OXFORDSHIRE
STRATEGIC RAIL FREIGHT INTERCHANGE

Chapter 3: Transport
Appendix 3.1: Transport Assessment Part 10 of 11 – Appendices 35 to 43

M40 J9 HIGHWAY DESIGN REVIEW

Project	**Oxfordshire Strategic Rail Freight Interchange (OxSRFI)**		
Document Number	OxSRFI-BWB-GEN-XX-RP-CH-0015	**BWB Ref**	NTH2479
Author	Simon Hilditch	**Status**	S3
Checked	Ryan Picknell	**Revision**	P01
Approved	Simon Hilditch	**Date**	24.03.2026

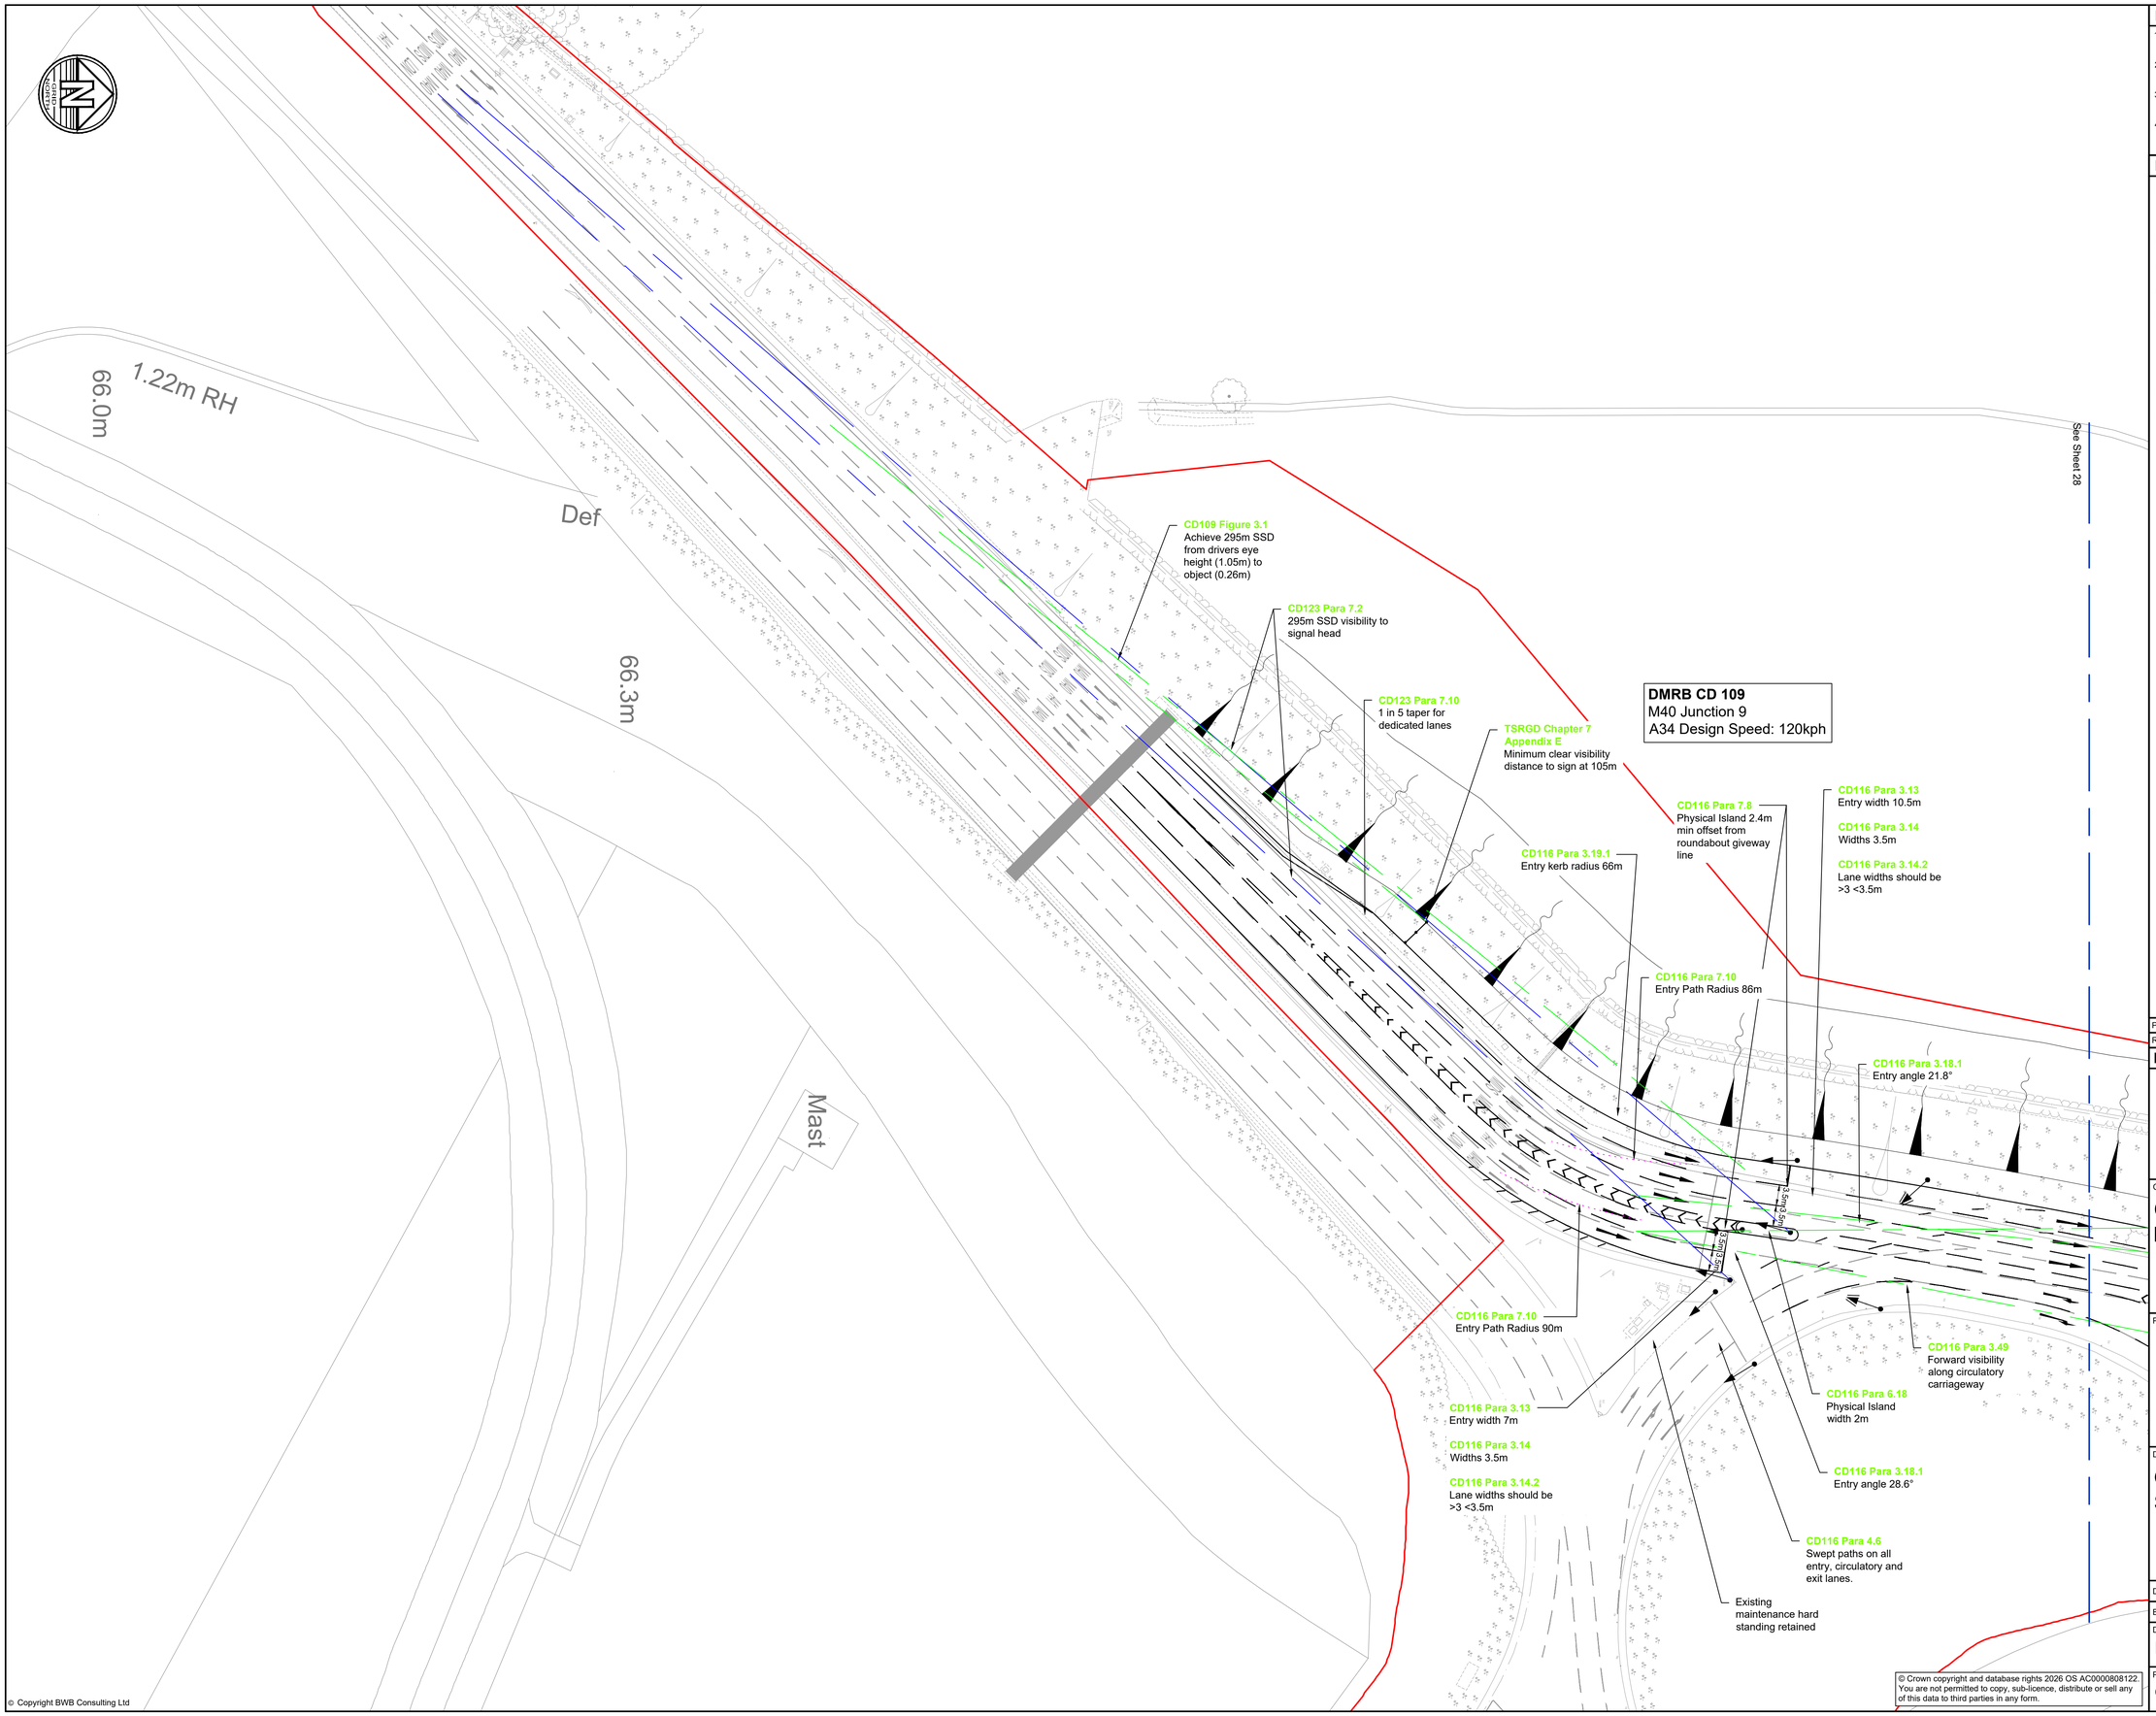
3.13	The taper by which the third lane is lost on the M40 slip road starts downstream of the bend approximately 40-50m into the slip road. This is to be welcomed. The adequacy of the taper length proposed should be confirmed by reference to CD 116 Figures 3.14b and 3.14j and para 3.19 (which in turn refers to TSM ch5 Table 7-4).	The lane reduction taper is shown in detail on drawing OxSRFI-BWB-HGN-28-DR-CH-0105 found at **Appendix B**. This is compliant with CD 127 Table 2.28.

3.13. The taper by which the third lane is lost on the M40 slip road starts downstream of the bend approximately 40-50m into the slip road. This is to be welcomed. **The adequacy of the taper length proposed should be confirmed by reference to CD116 Figures 3.14b and 3.14j and para 3.19 (which in turn refers to TSM ch5 Table 7-4).**
